North Dakota Department of Transportation

ADDENDUM 4 – JOB 19

TO: All prospective bidders on project NH-RSS-1-003(034)059, Job No. 19 scheduled for the November 14, 2014 bid opening.

Revised 10/31/2014	STATE	PROJECT NO.	SECTION NO.	SHEET NO.
	ND	NH-RSS-1-003(034)059	77	3

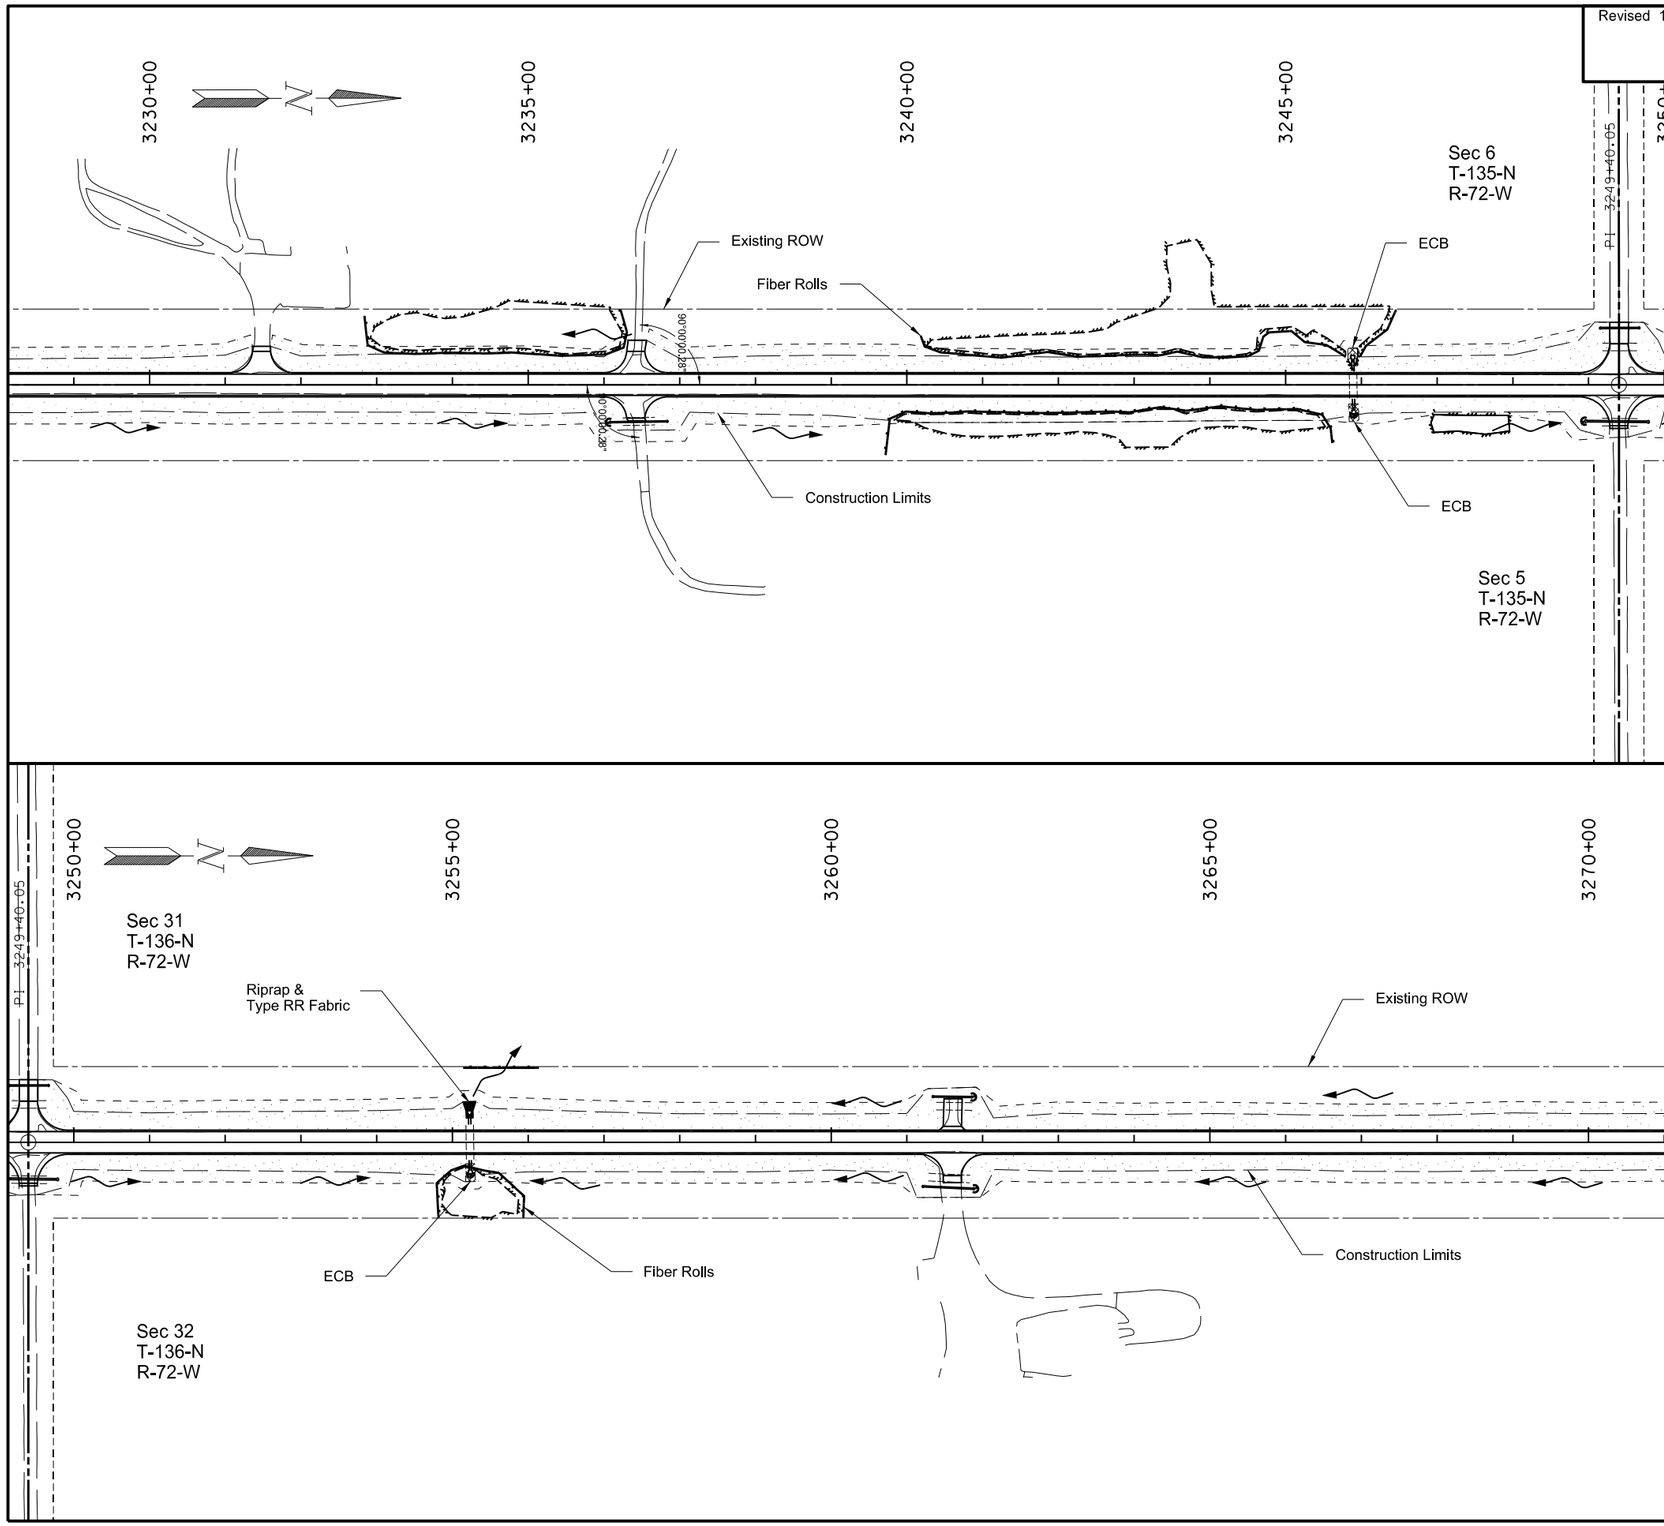
Section No. 77, Sheet No. 3:

- Added Wetland 44.
- Updated Construction Limits.
- Updated Seeding Boundary.

Revised 10/31/2014	STATE	PROJECT NO.	SECTION NO.	SHEET NO.
	ND	NH-RSS-1-003(034)059	77	20

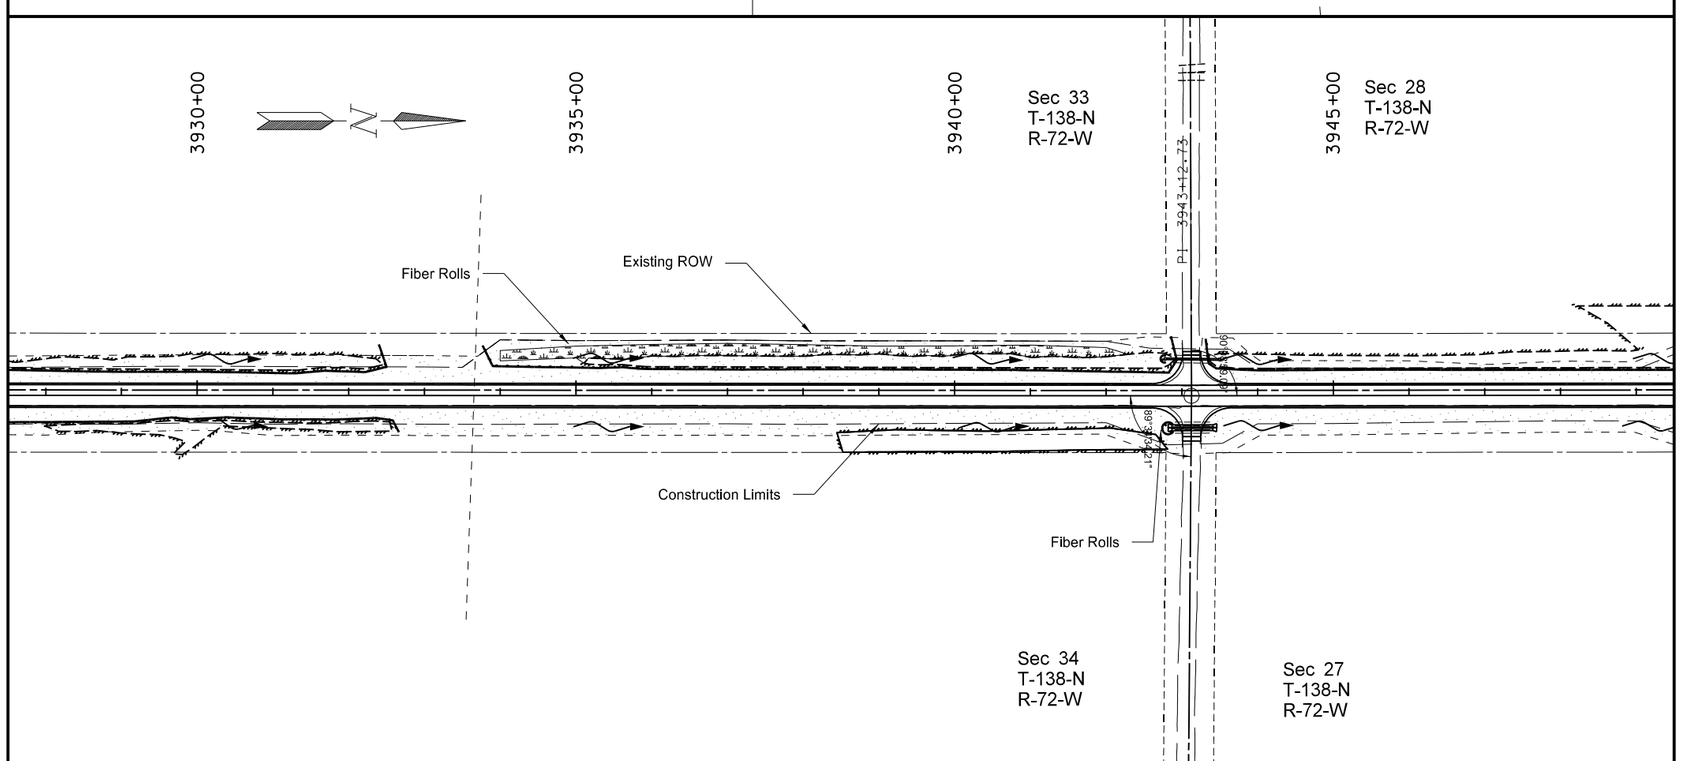
Section No. 77, Sheet No. 20:

- Updated the permanent seeding & the permanent mulch boundary.
- Increased Quantity of Fiber Rolls 20IN at Station 3930+25 Rt. from 510 LF to 605 LF.
- Updated Seeding Area.
- Updated Construction Limits.
- Added Wetland 14-E.

Revised 10/31/2014	STATE	PROJECT NO.	SECTION NO.	SHEET NO.
	ND	NH-RSS-1-003(034)059	77	30

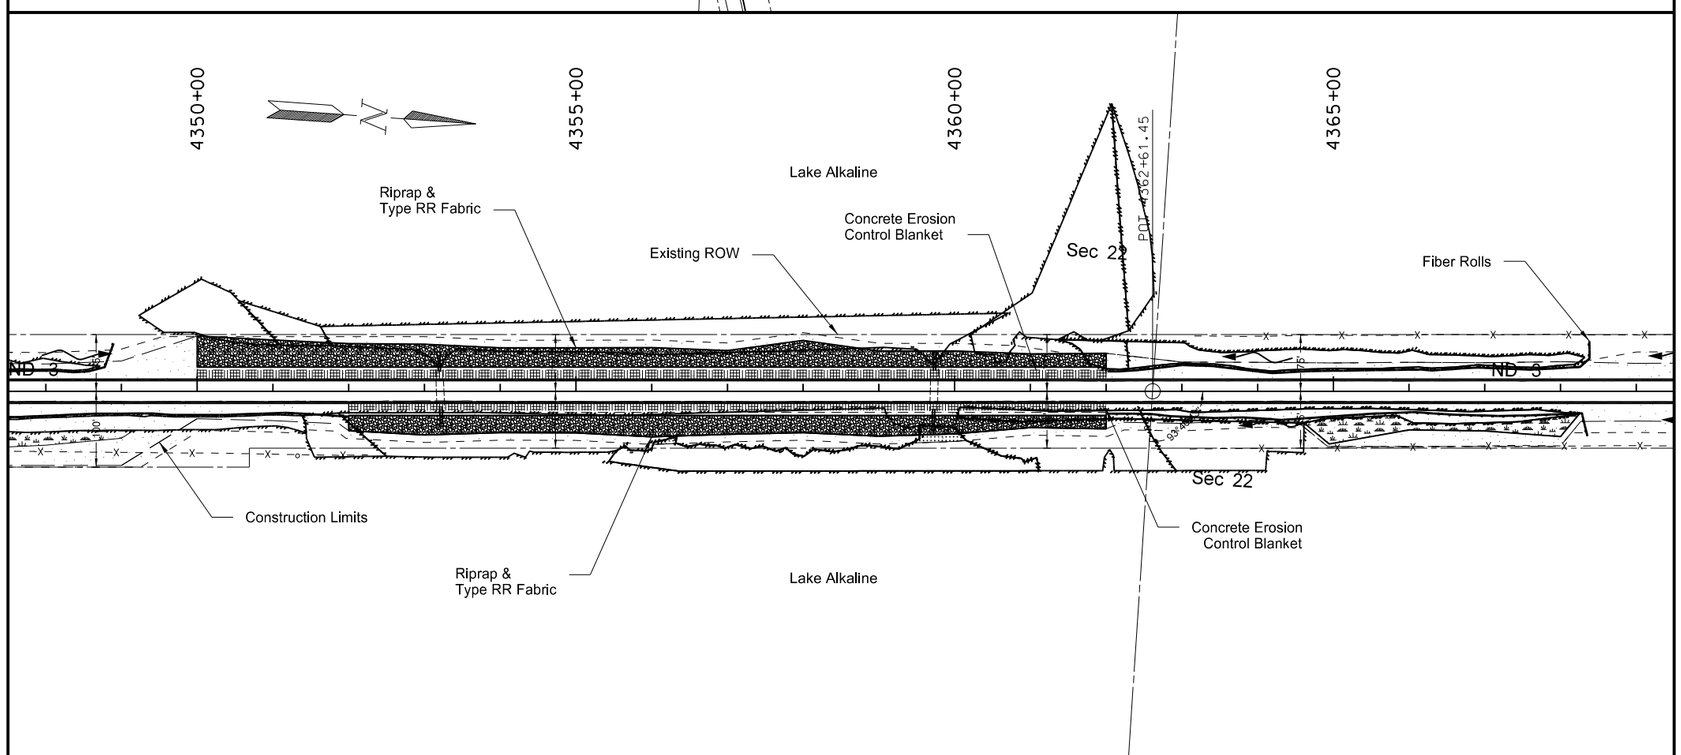
Section No. 77, Sheet No. 30:

- Revised wetlands.
